Nomination Form
Anadromous Waters Catalog

Name of Water Body Jordan Creek ☒ USGS Name ☐ Local Name

CORRECTION

Nom #24-511

Figure 1.—111-50-10620 route correction map.

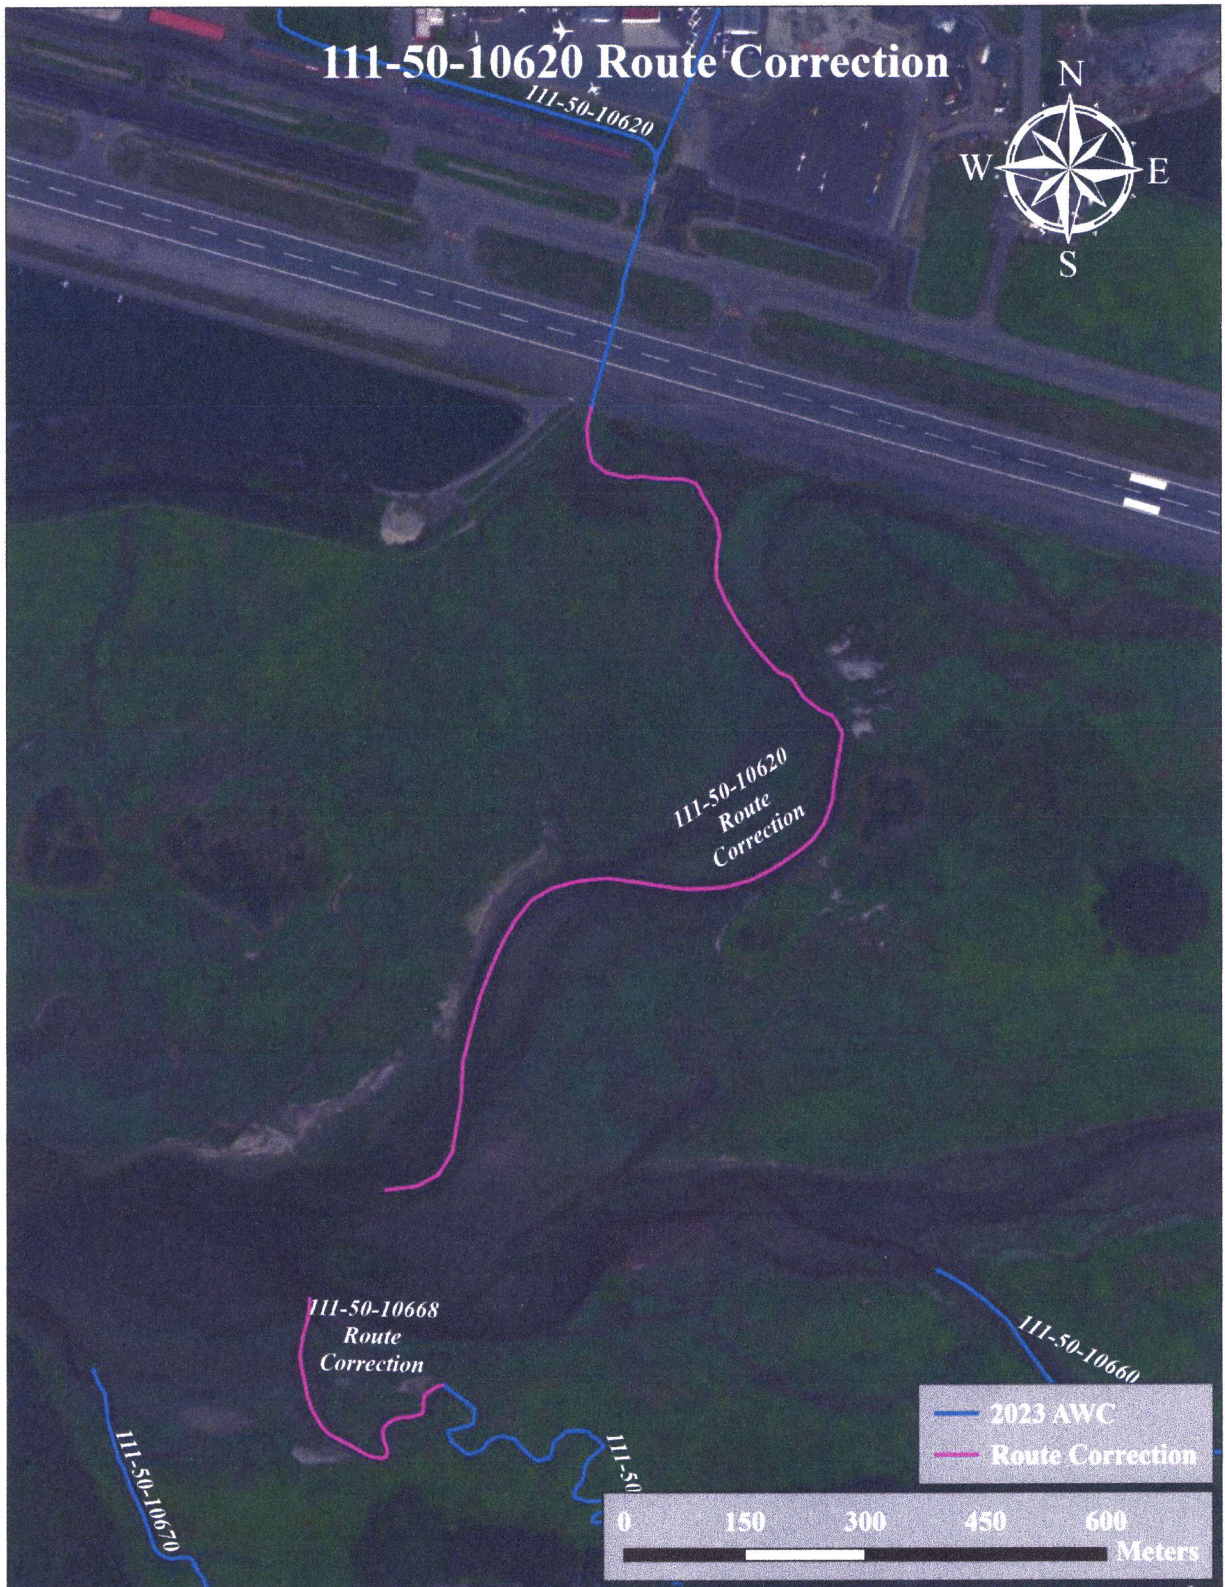
Findings: We surveyed this cataloged stream and found that the stream path is incorrectly mapped. The lower reach of the stream should be extended for clarification, particularly in light of potential alternatives identified for eventual construction of a second bridge crossing between Juneau and Douglas.

Recommendations: Correct Stream No. 111-50-10620 in the anadromous waters catalog to reflect the field verified stream path. Please extend stream into the intertidal (Figure 1).
